# INDEX INSTRUMENT SERVICE ADVISORY

PRODUCT: ALCYON (TM) 300 Rev 1 (119)	DATE: 17-AUG-1999
--------------------------------------	----------------------

SUBJECT: Dual Voltage Heater	ISA#: 119-018
ORIGINATOR: Emil Jivan	PRODUCT: ALCYON® 300 Rev 1 (119)
APPROVED: Kathy Jennings 17-AUG-1999	EFFECTIVITY DATE: 17-AUG-1999

A new type of Heater Assembly has been approved for use with the Alcyon Analyzer. The new Heater Assembly will be installed in new instruments beginning in August or September 1999. The cut-in serial numbers for this ISA are: 1986, 1987, 1993, 1994, 2126, and above This ISA includes the following information:

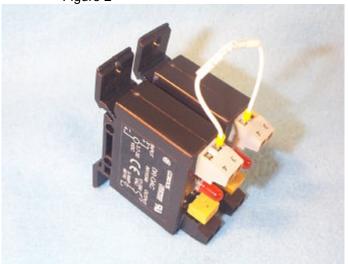
Action	Comments	
R	emoving Old Heater Assembly		
1	Remove all Patient Samples from Sample Carousel.		
2	Perform the Short Term Shutdown found in VP-01.		
3	Perform RR-C1.13 to remove old Heater Assembly.	Unplug Heater Assembly Cable (P203, W23) from the back of the instrument prior to removing Heater Assembly.	
Н	eater Resistance Verification		
1	Check the resistance between the two wires, labelled P184 pin 3 and P120B RLY. Verify that the resistance measures between 76 and 84 Ohms.		
2	Check the resistance between the two wires, labelled P184 pin 4 and P121B RLY. Verify that the resistance measures between 76 and 84 Ohms.		
ln	Installing New Heater Assembly		
1	Perform RR-C1.13 in reverse order to install the new heater.	During installation add an additional Cable Clamp to keep Colorimeter Cables away from the heater. <i>Verify that the cables are not interfering with the heater.</i> See Figure 1.

Figure 3

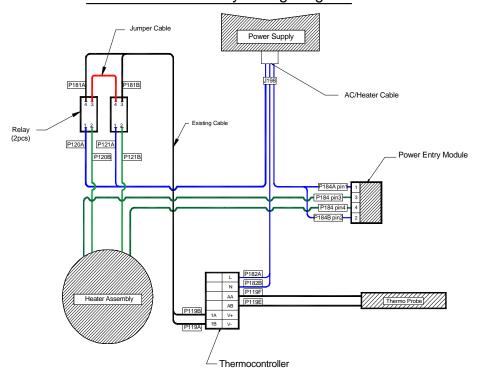
2	Slide both Relays on the existing Relay Mounting	The mounting method is the same as the old
	Bracket.	one.
Re	eplacing AC/Heater Cable	
1	Remove old AC/Heater Cable.	
2	Connect AC/Heater Cable J198 to Power Supply and	Verify connection by slightly pulling the cable.
	thaen secure it with a Tie Wrap around the	
	connectors. See Electrical Schematic in Figure 3.	
3	Connect AC/Heater Cable to Power Entry Module	
	(PEM) as follows:	
	Terminal P184A pin1 to Position 1 of PEM	
	Terminal P184B pin2 to Position 2 of PEM	
	See Electrical Schematic in Figure 3.

4 Connect AC/Heater Cable to Both Reaction
Temperature Relays as follows:
Terminal P120A to Position 1 of the Left Relay
Terminal P121A to Position 1 of the Right Relay
See Electrical Schematic in Figure 3.

5 Connect AC/Heater Cable to Temperature Control
Module (Thermocontroller) as follows:
Terminal P182A to Line
Terminal P182B to Neutral
See Electrical Schematic in Figure 3.

1 Connect Heater Assembly Cables to Both Reaction
Temperature Relays as follows:
Terminal P120B to Position 2 of the Left Relay
Terminal P121B to Position 2 of the Right Relay
See Electrical Schematic in Figure 3.

Terminal P184 pin3 to Position 3 of PEM Terminal P184 pin4 to Position 4 of PEM See Electrical Schematic in Figure 3.

Terminal P181A to Position 4 of the Left Relay Terminal P181B to Position 3 of the Right Relay See Electrical Schematic in Figure 3.

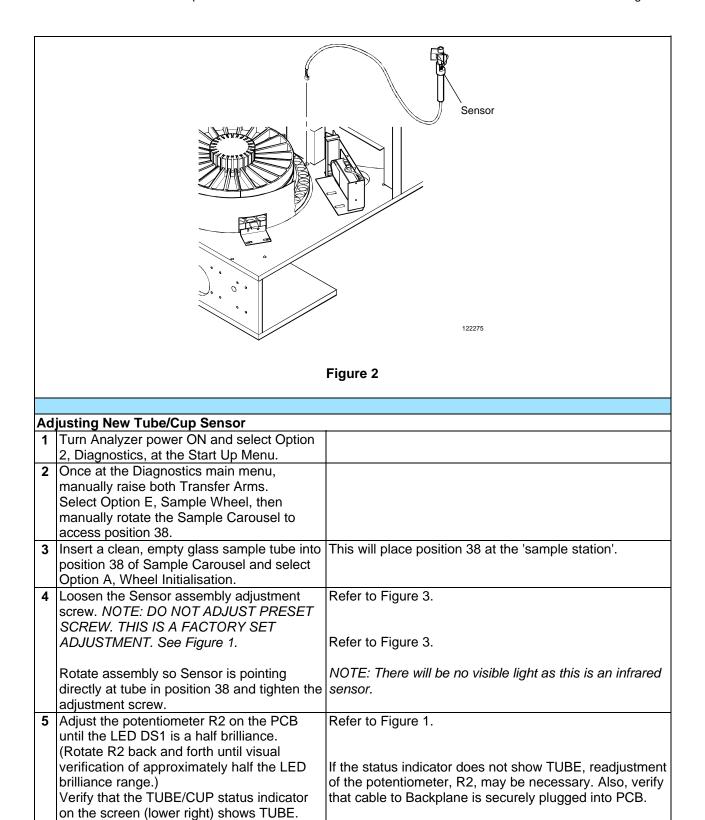
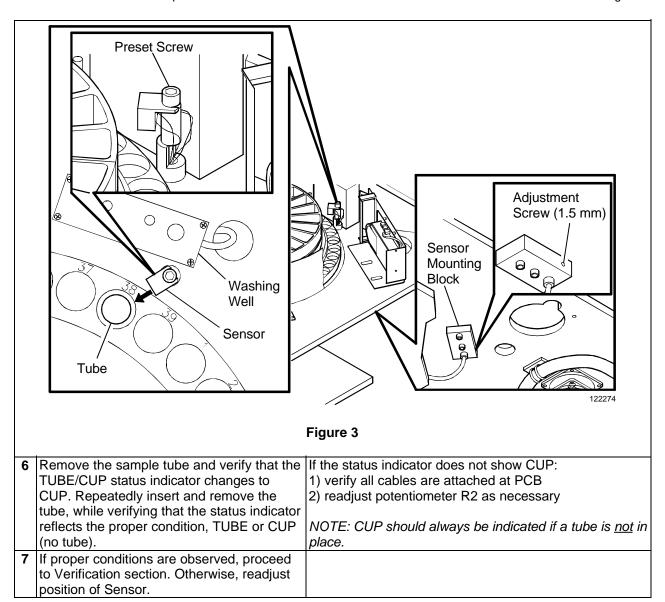
The new sensor is a reflective infrared emitter/detector. It is mounted on a post where the old style fiber optic detector was located. The sensor is directed toward the position being sampled on the Sample Carousel. The sensor is connected to the new PCB, which supplies current to the emitter and amplifies the output of the phototransistor.

The PCB is mounted in the same place as the previous controller unit and is mounted on two plastic standoffs. Adjusting the sensitivity of the circuit does not require a tool. A single-turn thumbscrew style potentiometer is used. The PCB allows adjustment of the amplifier gain to compensate for sensor variability before the photodetector output is converted to digital signal.

Figure 1

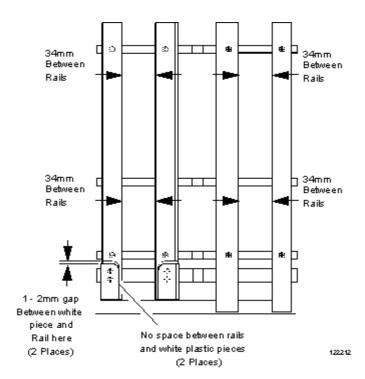
- 7. Pg. 5-101, For VP-44, refer to ISA 120-001.
- Pg. 5-105, Incorrect figure for the Load/Unload alignments, refer to figure #1 following this section.

Figure 2

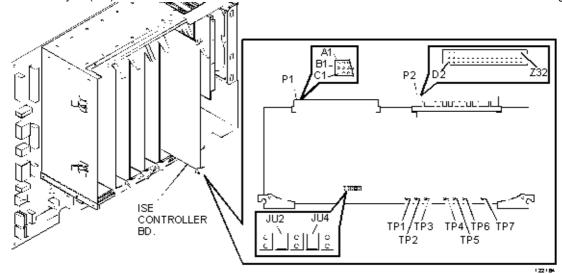
- 5. Pg. 4-225, Incorrect figure for ISE Controller BD., refer to figure #2 following this section.
- 6. Pg. 4-230 Replace existing text under verification step 1a, with 1) Initialize Sample Transfer Arm, 2) Initialize Sample Syringe and remove text in line #3.

Securing the Sample Probe

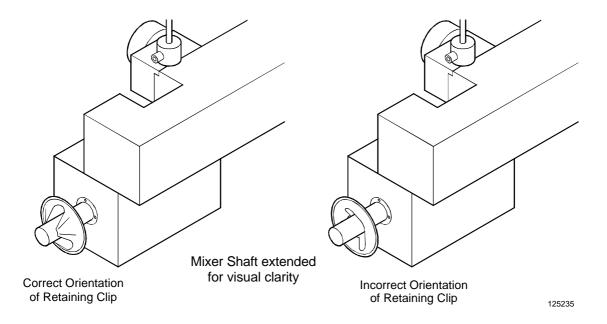
The Sample Probe must be properly secured by the Probe clamp and thumbscrew.

- a) If the Probe thumbscrew is too loose, the spring-loaded mixer shaft will push the probe out of position (not vertical) causing it to crash into the Wash Well and/or cuvette. As long as the Probe is properly secured by the thumbscrew, the Probe position should not be affected by the spring-loaded shaft.
- b) If the Probe thumbscrew is too tight, the mixing action may be inhibited. Do not overtighten the thumbscrew.

## Mixer Wiring

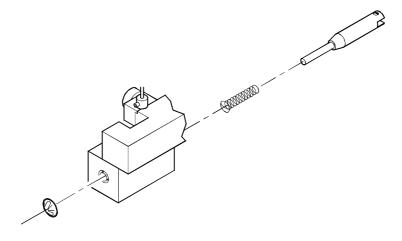
Verify that the two white Mixer wires do not hang down but are secured up inside the Sample Arm immediately after exiting the Mixer coil. If not positioned properly, the wires will interfere with the ISE Probe Retaining Bracket as it moves across the Sample Arm.
